# ADDENDUM NO. 1

**Project Description:** 2026 Leisure Services Parking Lot

**Owner:** City of Waverly

**BMI Project No.:** 0G1.133771

SHEET  
D.01

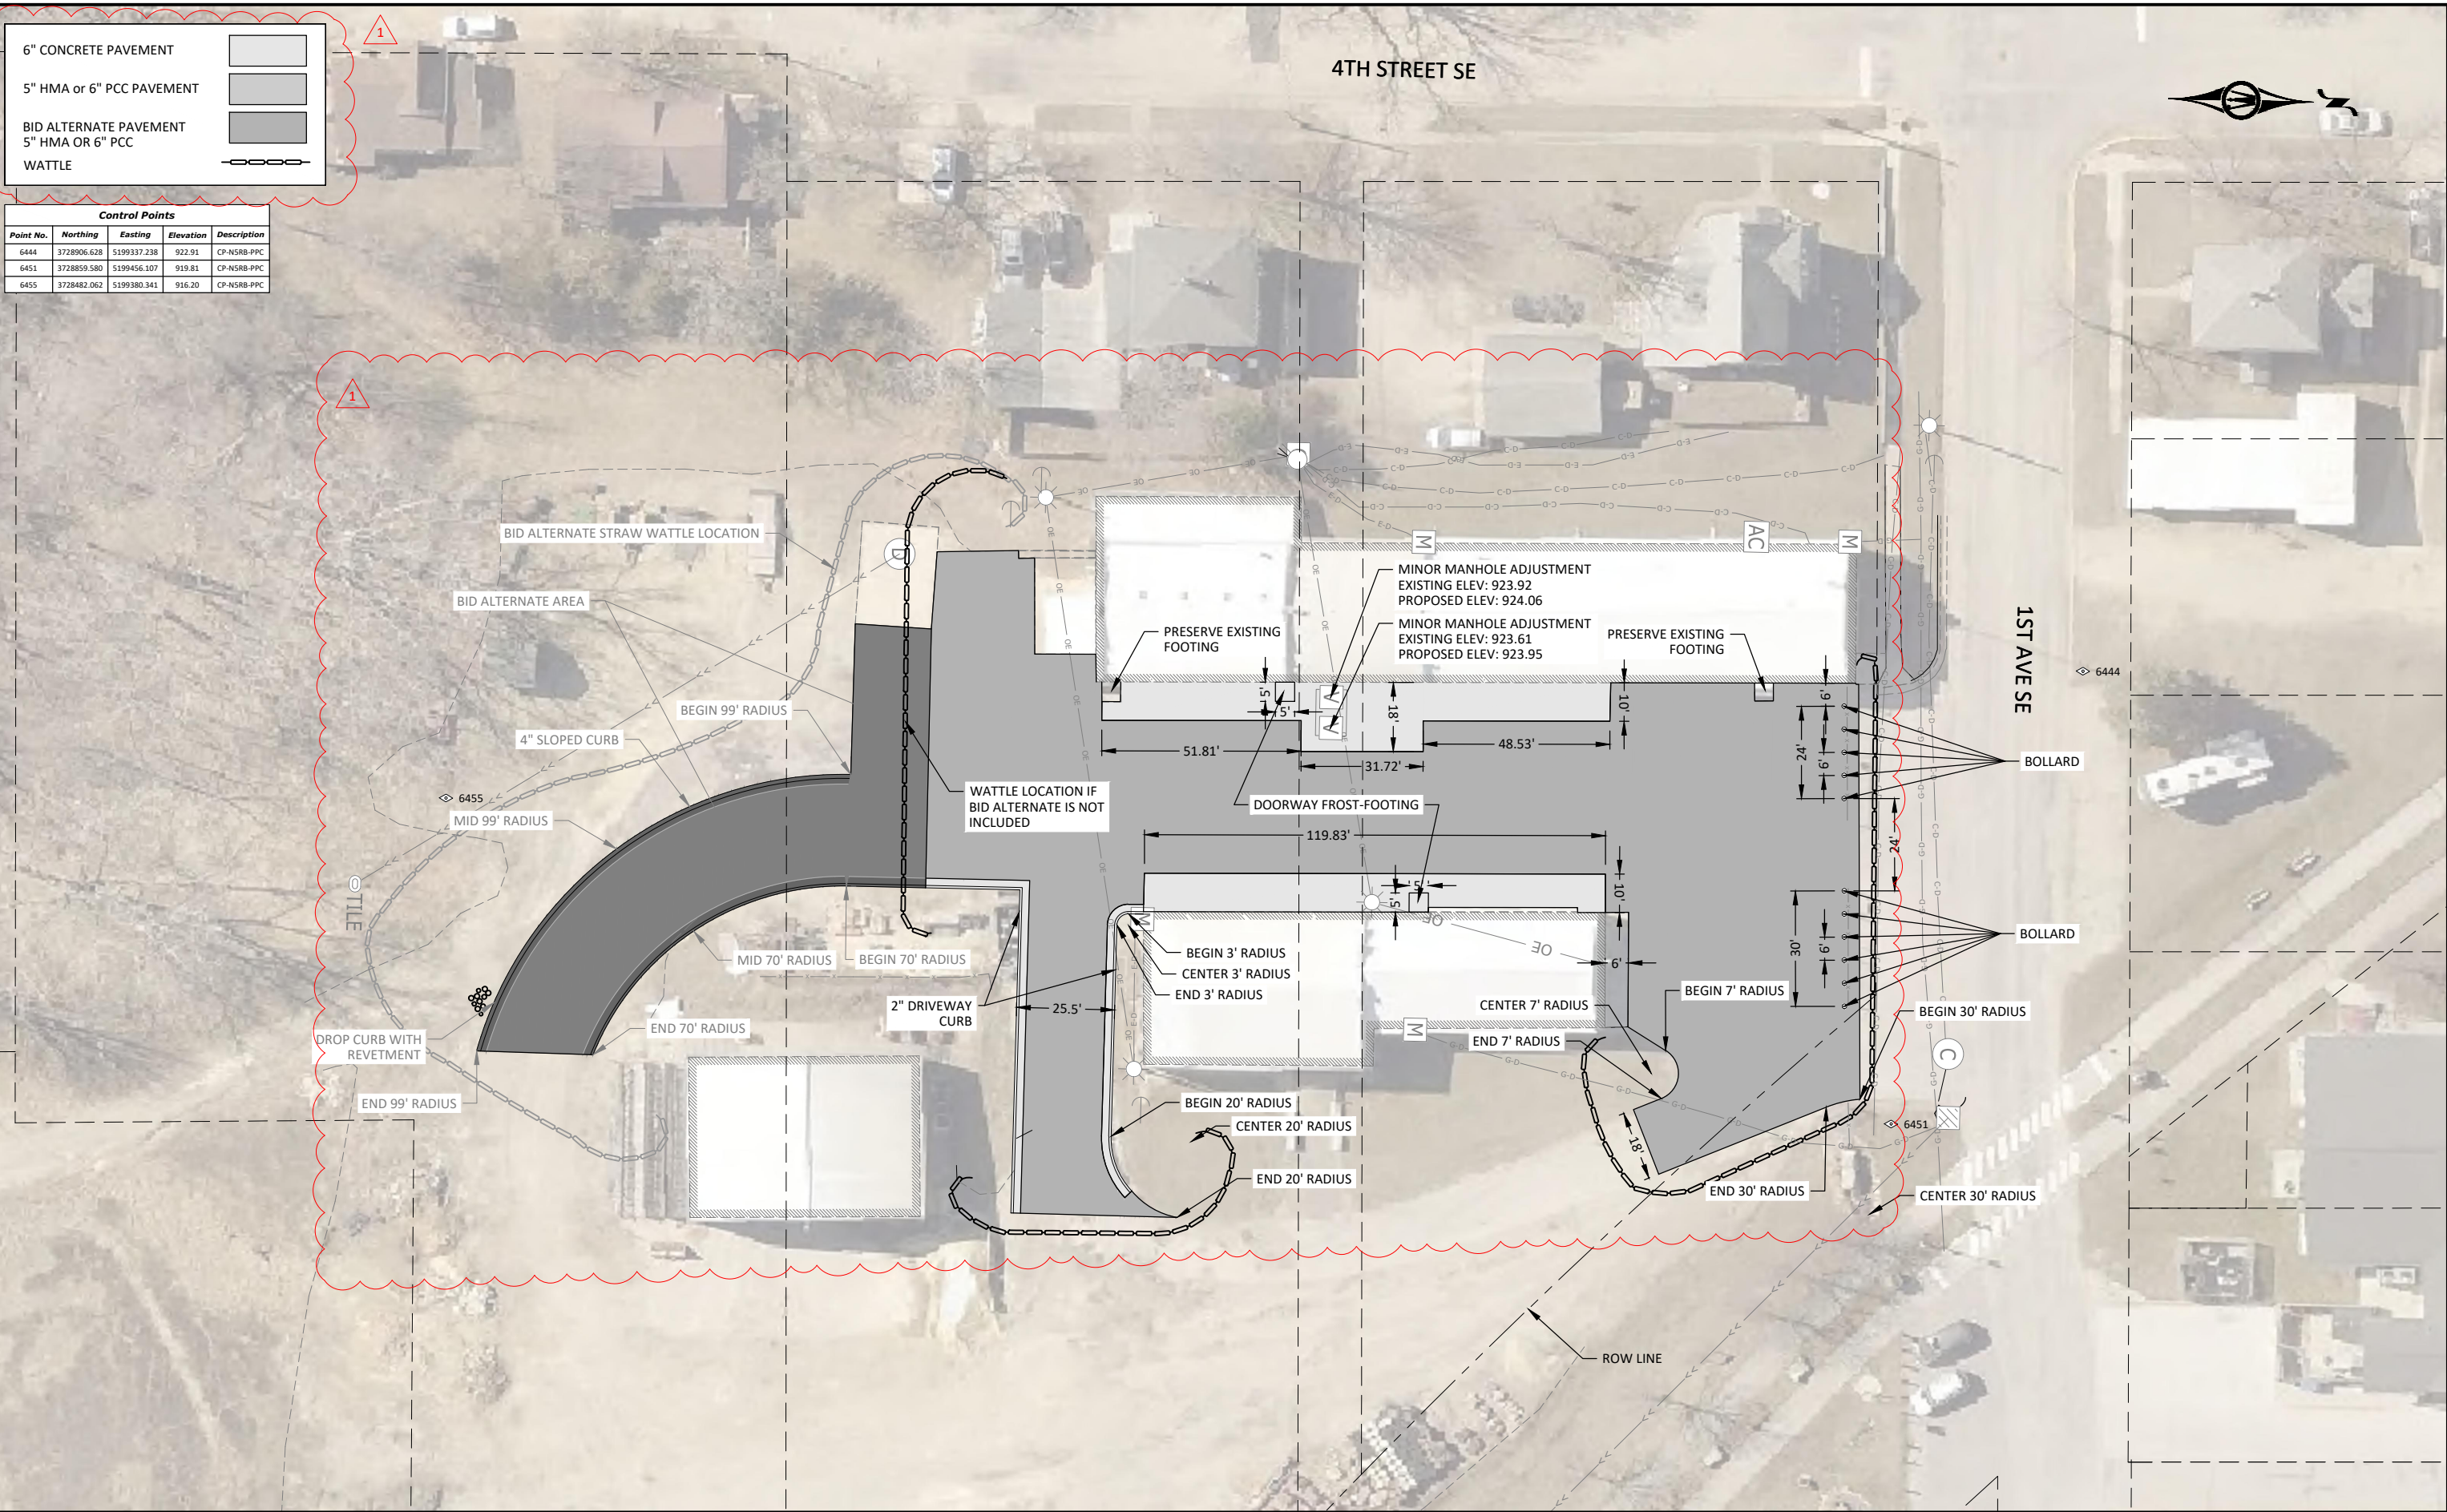
- Sheet D.01 – Change the pavement material legend from "HMA PAVEMENT" to "5" HMA or 6" PCC PAVMENT" and "BID ALTERNATE HMA PAVEMENT" to "BID ALTERNATE PAVEMENT 5" HMA OR 6" PCC".

5" HMA or 6" PCC PAVEMENT

BID ALTERNATE PAVEMENT  
5" HMA OR 6" PCC
